# Response to Submissions Report Goterra Pty Ltd Development Application – DA 291.1/2023 Resource Recovery Facility

Re: **Unit 3, 132 Newton Road, Wetherill Park (DA219.1/2023)**  
**Traffic Engineering Services**  
**Response to Request for Information (RFI)**

**APPLICATION NO.: DA 219.1/2023**

**Figure 1: Vehicular Path of Travel**

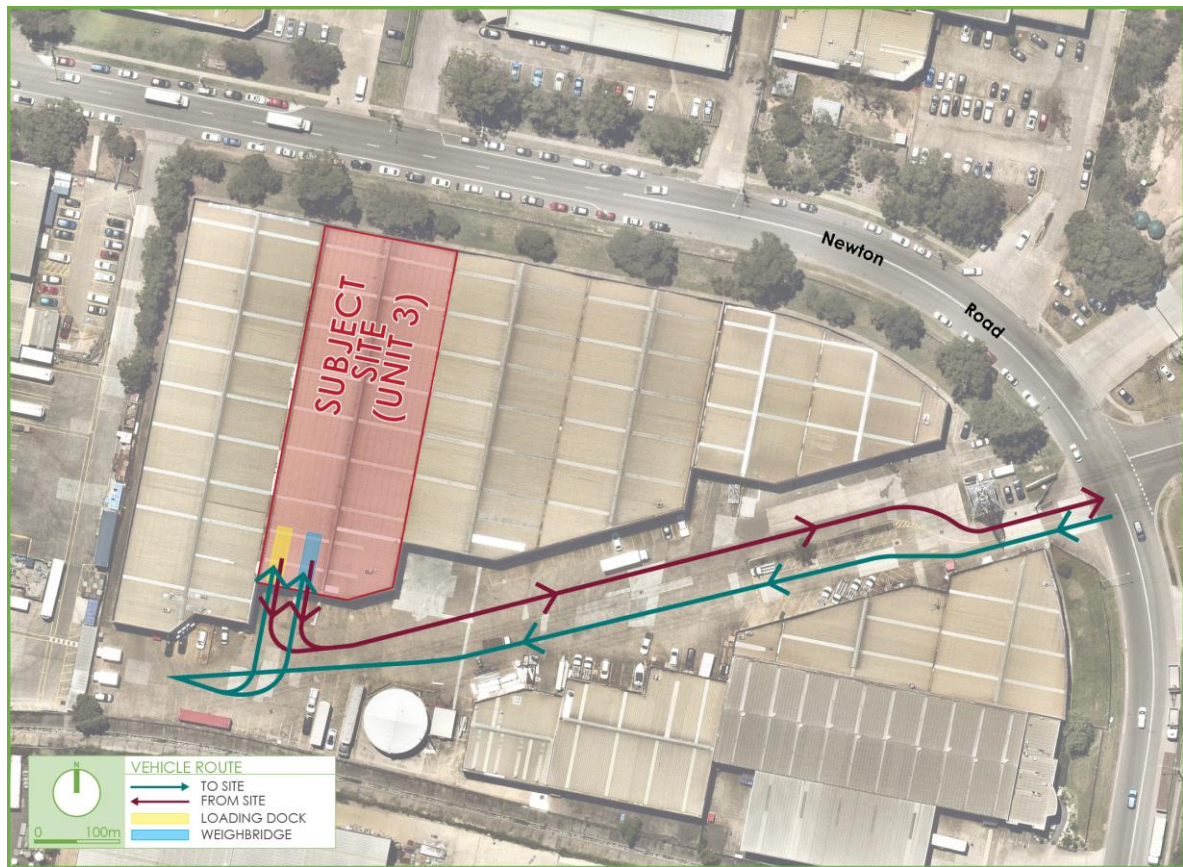
*"Amended Architectural Plans shall be submitted to Council which clearly dimension the aisle width between the car parking spaces and the loading dock and define the direction of travel within the site. The Applicant shall also demonstrate that 12.5 metre trucks can be satisfactorily accommodated within the unit. The provision of designated loading bays shall comply with Table 4.1 of AS 2890.2:2018. The Applicant shall also provide information on the grades of the ramp for truck entry for Unit No. 3 to comply with the requirements of AS/NZS 2890.1:2004."*

*"Amended Architectural Plans shall be submitted to Council which clearly dimension the aisle width between the car parking spaces and the loading dock and define the direction of travel within the site. The Applicant shall also demonstrate that 12.5 metre trucks can be satisfactorily accommodated within the unit. The provision of designated loading bays shall comply with Table 4.1 of AS 2890.2:2018.*

Reference should be made to the amended architectural plans provided in **Attachment 2** showing aisle width dimension between the car parking spaces and loading dock. All parking spaces are provided as User Class 2 spaces with minimum dimensions 2.5m x 5.4m in accordance with AS2890.1 (2004). Direction of vehicle travel within the subject site is shown in Figure 1 below and summarised as follows:

Vehicle access to the subject site (IN):

1. Enter 132 Newtown Road industrial estate in a forward direction, southbound.
2. Continue straight along the internal circulation roadway, southbound.
3. Access the weighbridge / loading dock of Unit 3 by undertaking a reverse manoeuvre.

Vehicle egress from the subject site (OUT):

1. Vehicles egress the loading dock of Unit 3 in a forward direction.
2. Turn left onto the circulation roadway, northbound.
3. Exit 132 Newtown Road industrial estate and turn left or right onto Newtown Road.

Drawing Title  
Unit 3 Loading Dock Ramp  
12.5m HRV  
Underside Clearance Test  
Reverse Entry & Forward Egress Manoeuvre

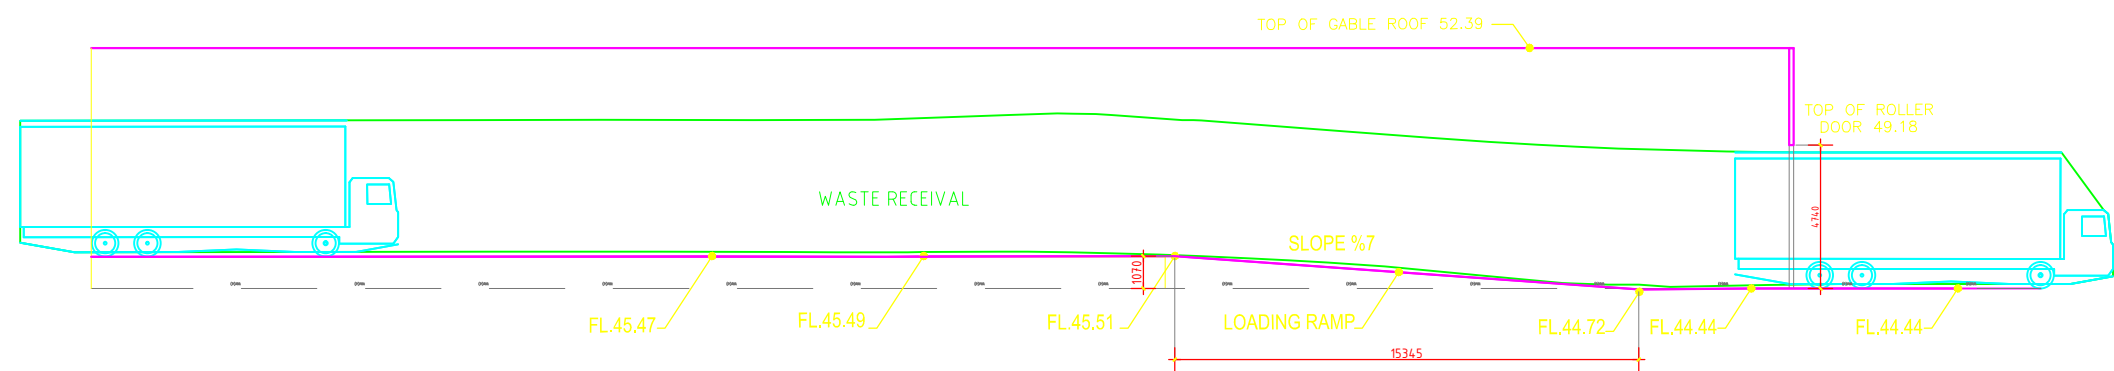
*The Applicant shall also provide information on the grades of the ramp for truck entry for Unit No. 3 to comply with the requirements of AS/NZS 2890.1:2004".*

Reference should be made to the vertical clearance assessment provided in **Attachment 4** demonstrating satisfactory operation of the ramp in accordance with AS/NZS2890.1:2004.
